Access Compliance Report Public Rights-of-Way (Curb Ramps)

Main Street: N/A		Cross Street: CECIL_PASTURE_RD		Location:	N
ADA ID: RPRK211026130417	Ramp Type: Type 4 - Parallel	Initial Pass/Fail: Fail	Overall Compliance: No	Severity Score:	15

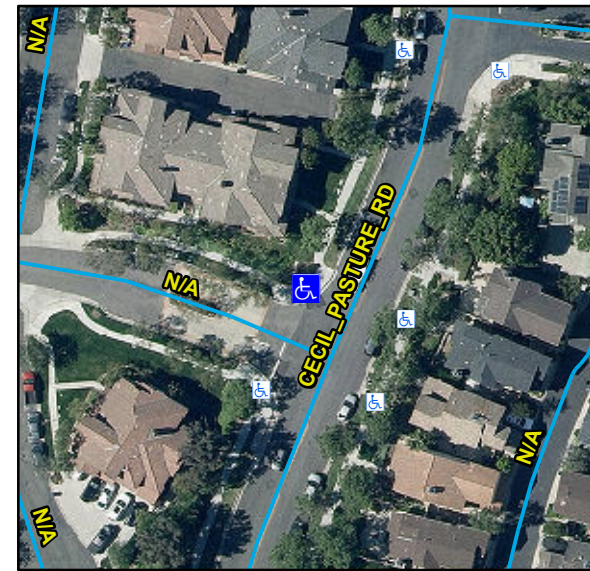
R204.3, R304.3.2, STD 1115

Compliance	Description	Data	Compliance	Description	Data
N/A	Ramp Length LT (in)	115	N/A	Ramp Length RT (in)	114
Yes	Ramp Width LT (in)	89	Yes	Ramp Width RT (in)	89
No	Ramp Run Slope LT (%)	9.5	Yes	Ramp Run Slope RT (%)	2.7
Yes	Ramp Cross Slope LT (%)	0.6	Yes	Ramp Cross Slope RT (%)	0.7
N/A	Landing Present	N/A	N/A	DWS Provided	N/A
N/A	Landing Length (in)	N/A	N/A	DWS Contrast	N/A
N/A	Landing Width (in)	N/A	N/A	DWS Length (in)	N/A
N/A	Landing Run Slope (%)	N/A	N/A	DWS Full Width	N/A
N/A	Landing Cross Slope (%)	N/A		DWS Offset Type	N/A
N/A	Landing Movement Obstructed?	N/A	N/A	DWS Offset Left (in)	N/A
	Landing Movement Type	N/A	N/A	DWS Offset Right (in)	N/A
N/A	Landing Shared	N/A			
N/A	Clear Space	Yes			
N/A	Clear Space To Crosswalk (in)	N/A			
N/A	Marked Crosswalk 1	No	N/A	Marked Crosswalk 2	No
	Crossing 1 Direction	SW		Crossing 2 Direction	SE
	Marked Crosswalk 1 Width (in)	N/A		Marked Crosswalk 2 Width (in)	N/A

Remove & Replace Curb Ramp With Two New Directional Ramps or Equivalent.
